**LOCAL HISTORIC DISTRICT:** Wilmore

**PROPERTY ADDRESS:** 1818 Wickford Place, Lot 1

**SUMMARY OF REQUEST:** New Construction

**HDC-2019-00363**

301 REAR ELEVATION  
A3.1

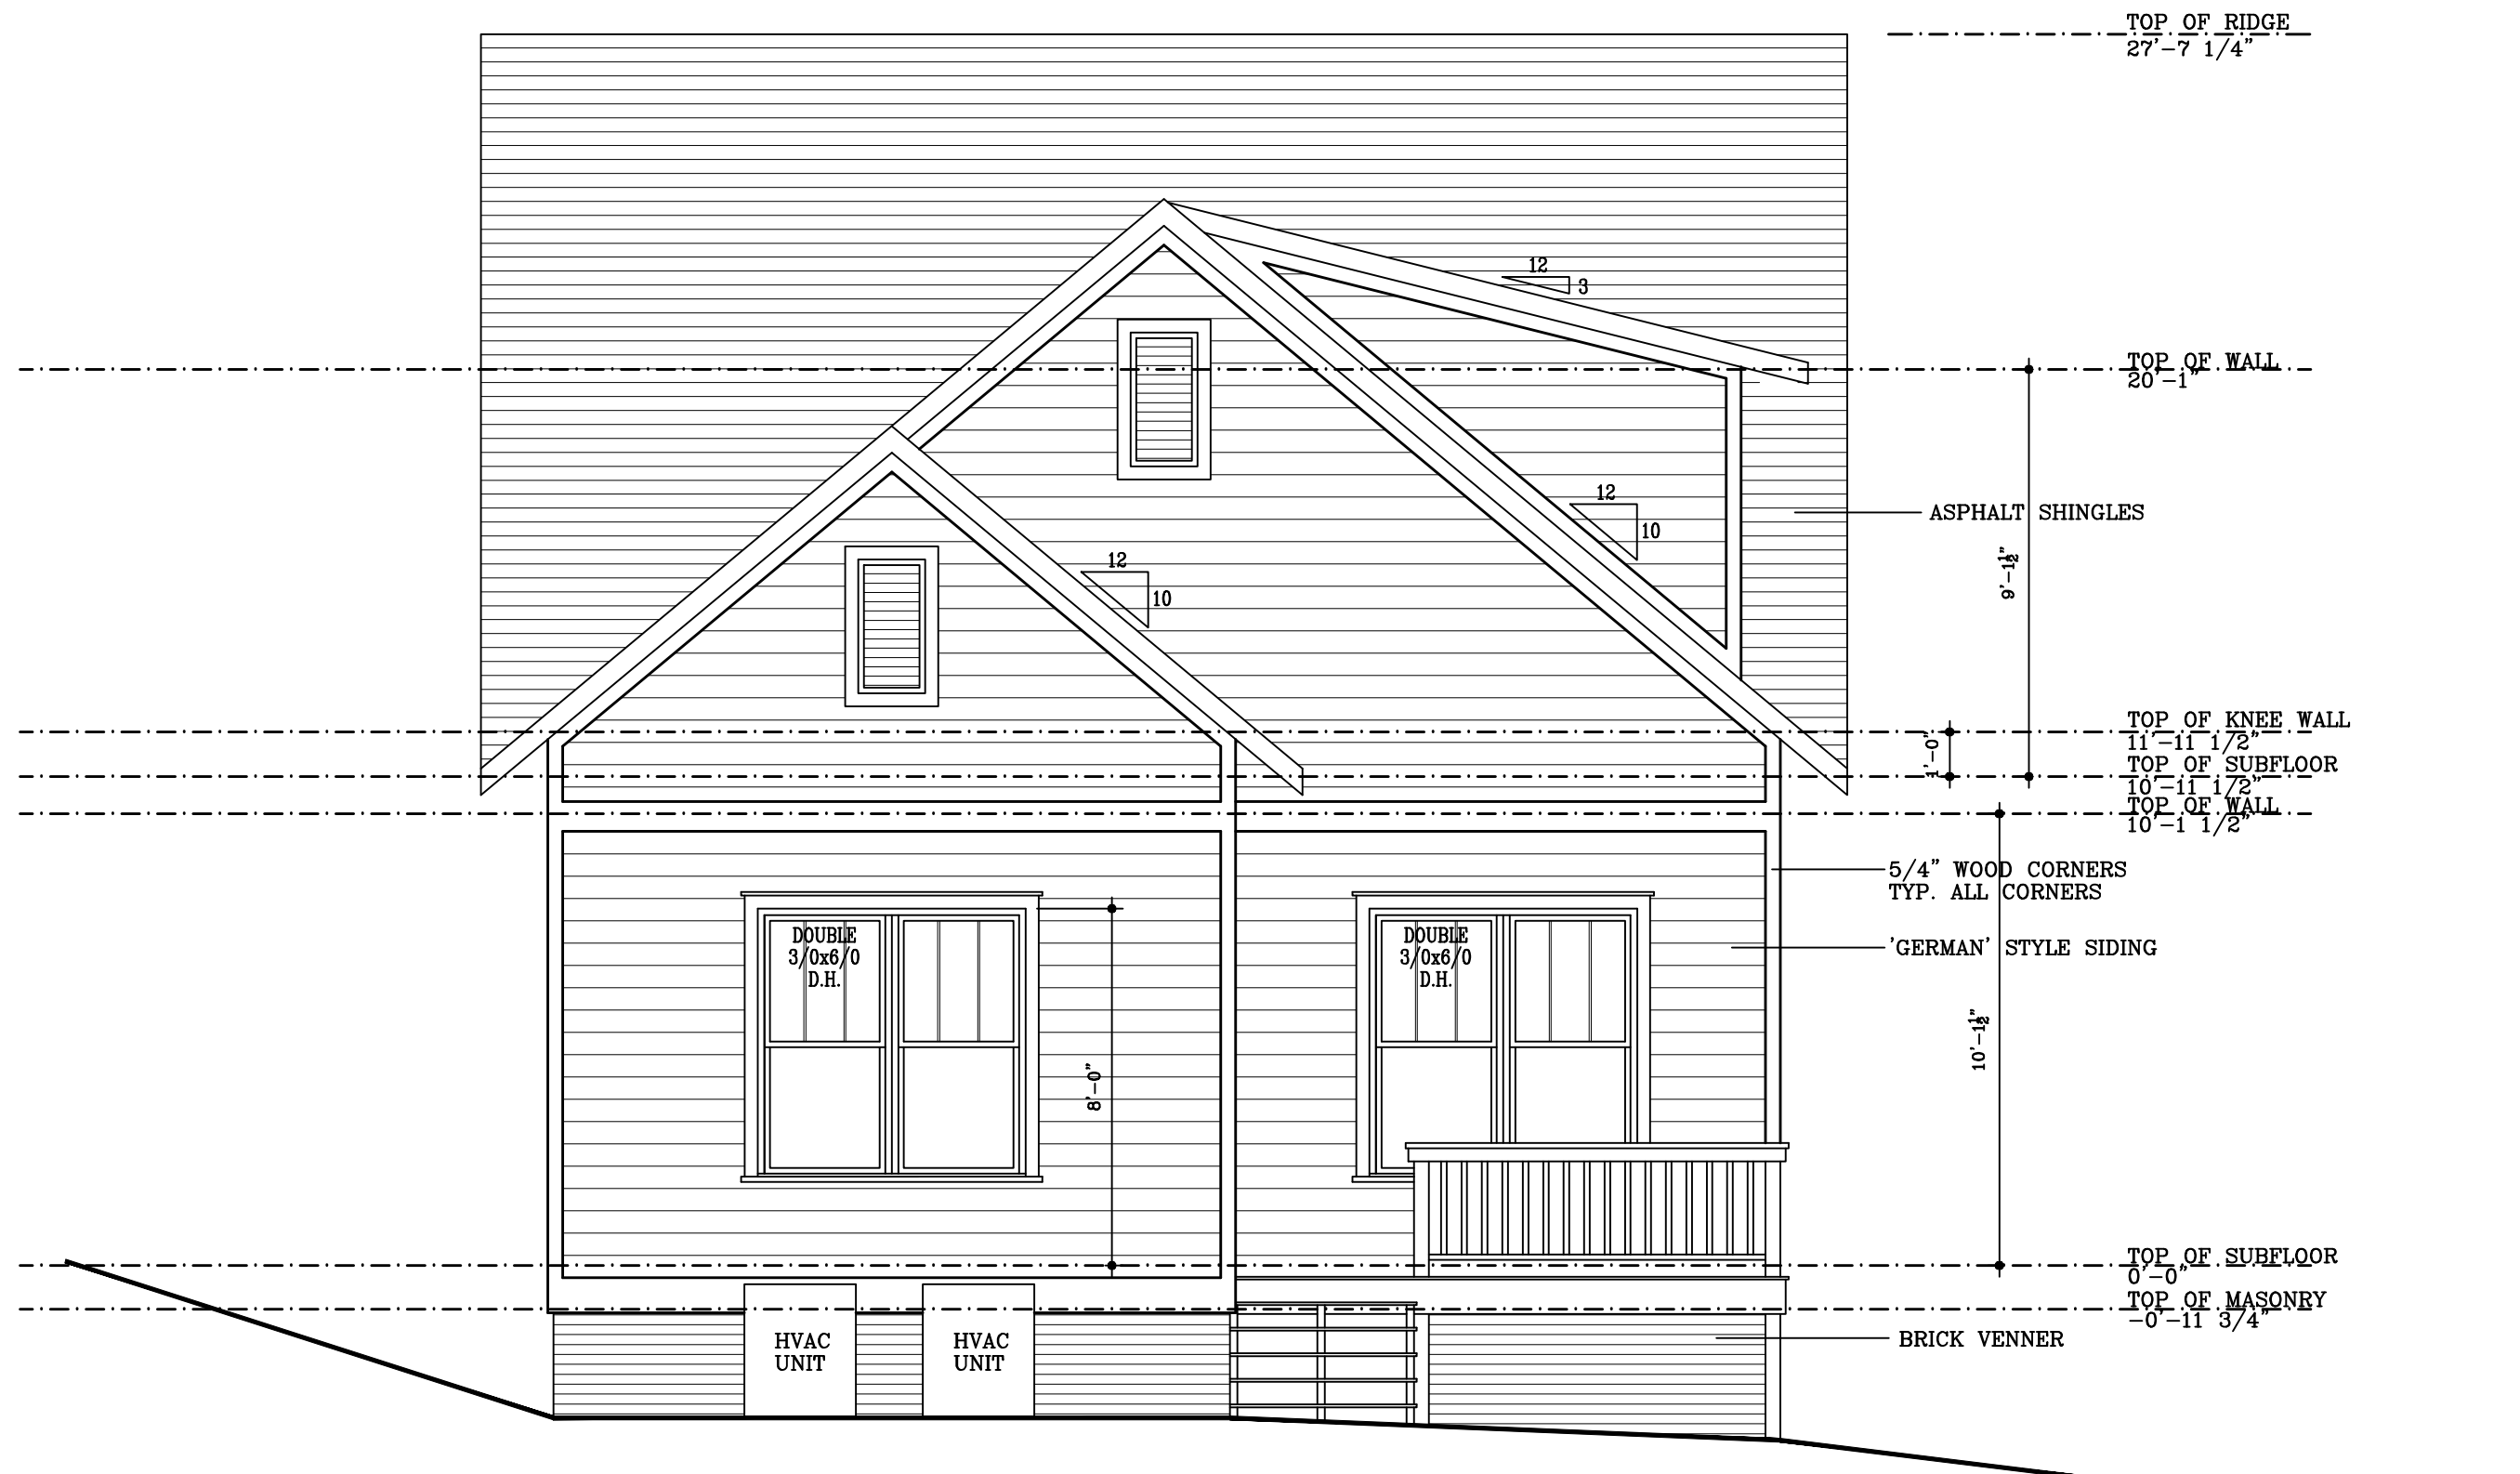
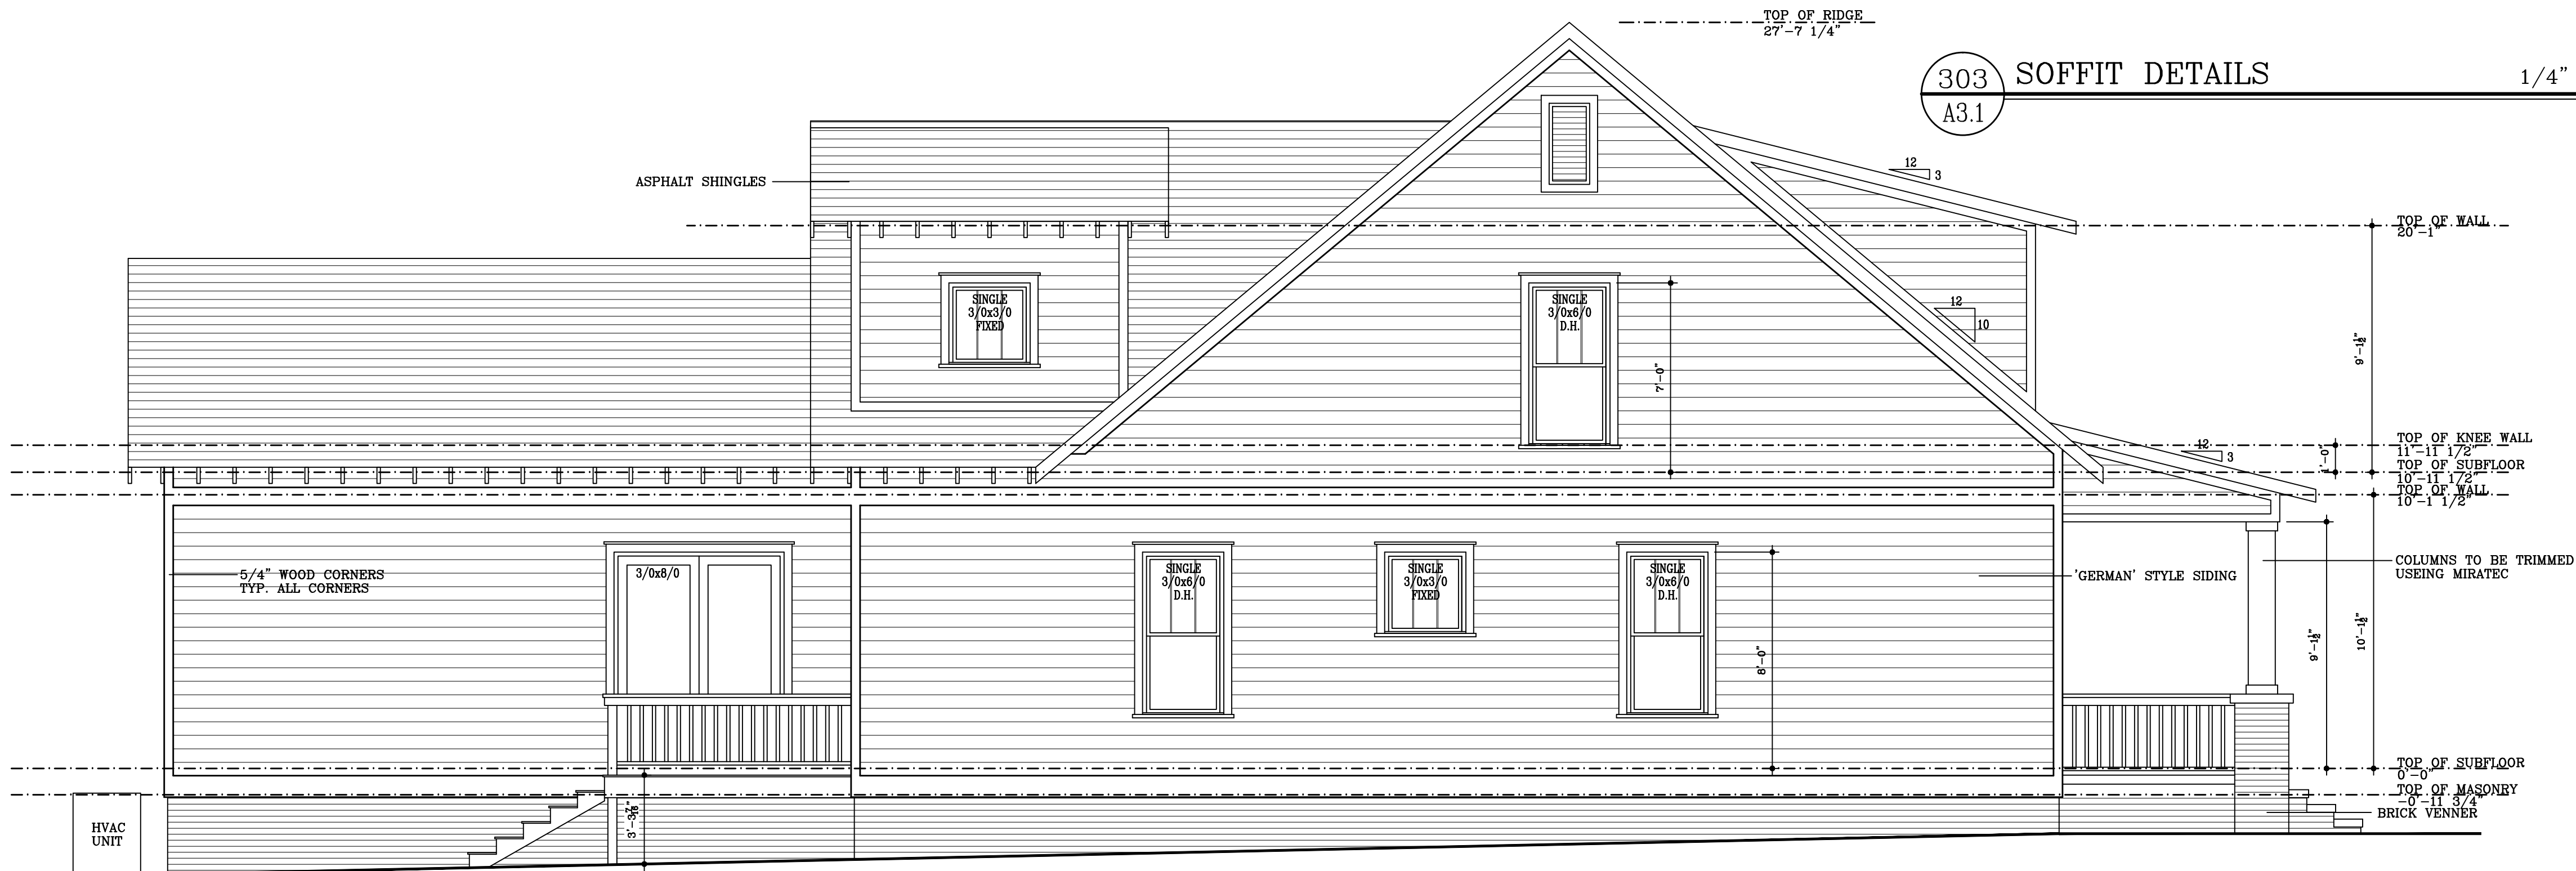
3. Roof overhang not changed per condition.
4. V-groove bead board soffit not noted on plans.
5. Staff concern over Elevation Notes on A3.1 that German-style siding, door, and window styles to be selected by owner.
6. The project is not incongruous with the district and meets guidelines for New Construction.
7. Staff Recommends reinstating the **Approval with Conditions with Staff to work with applicant**, per 10.4.1 of the Rules for Procedure.
8. If requested by a Commission member, or if an interested party has signed up to speak in opposition, then the HDC shall open the application for a full hearing.

## SOFFIT DETAIL – UPDATED OPEN TAIL

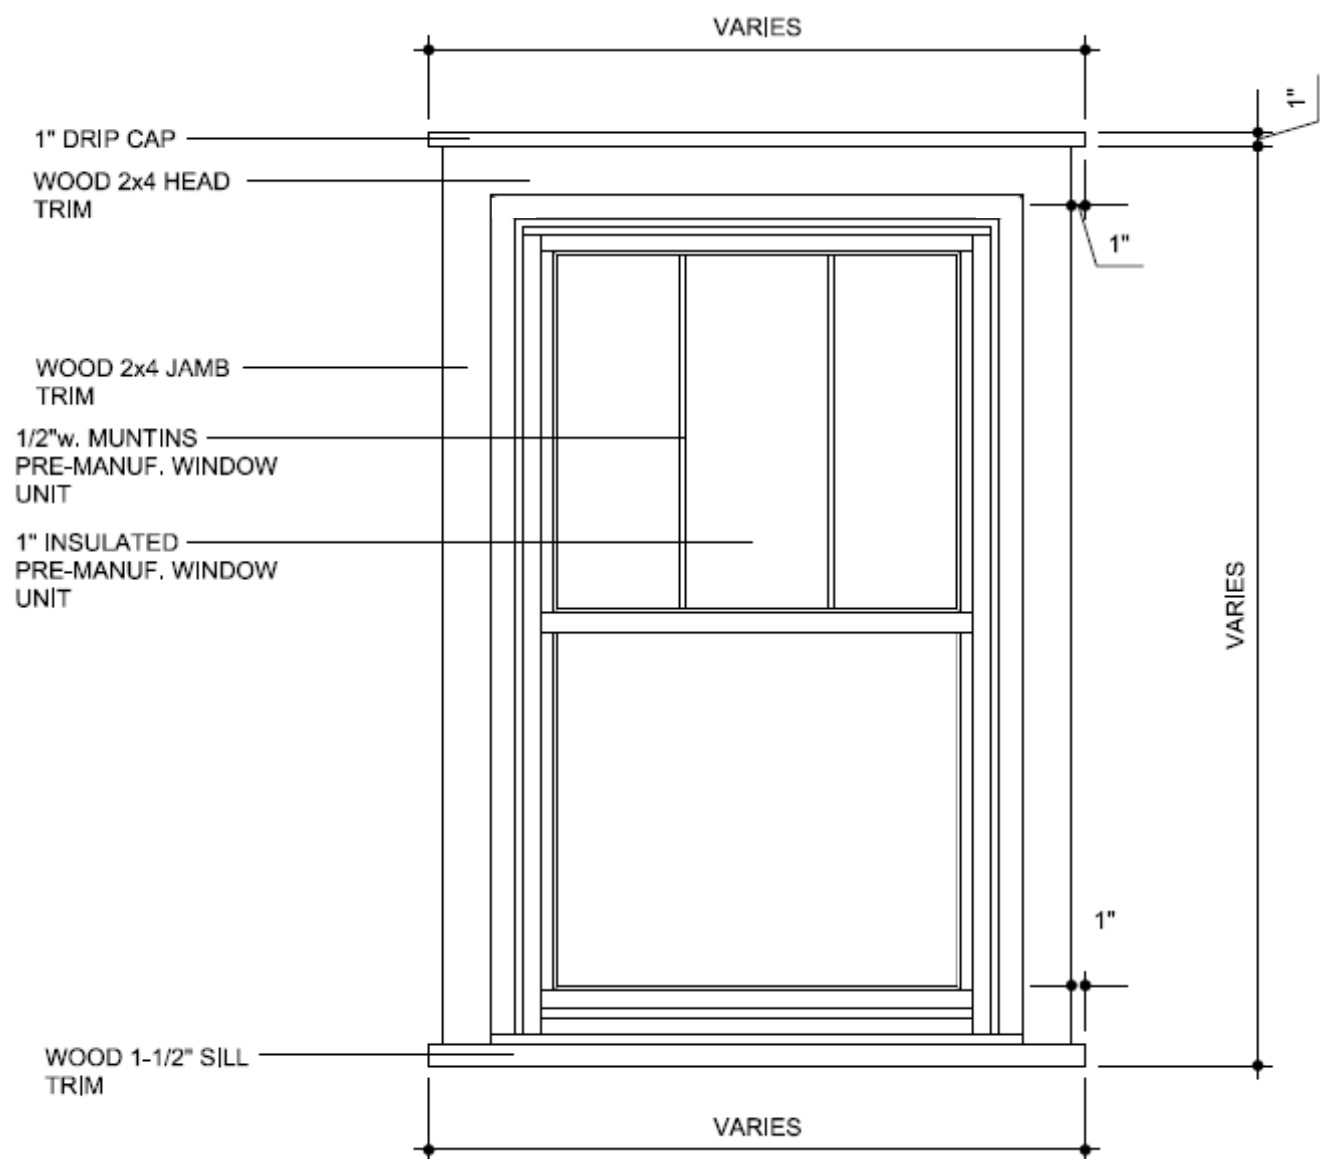
- *Miratek installed on columns, corners, fascia*
- *Windows– Take brick casing off, 4" wide non- tapered trim with 7/8 inch putty glaze*
- *Roof overhang extended to 24 inches at right angle to siding*
- *¾ individual V-groove bead board soffit*
- *2X8" barge rafters with bed mold installed base*
- *Tree protection plan*
- *Corner boards are to be equal to 5 ½ inches*
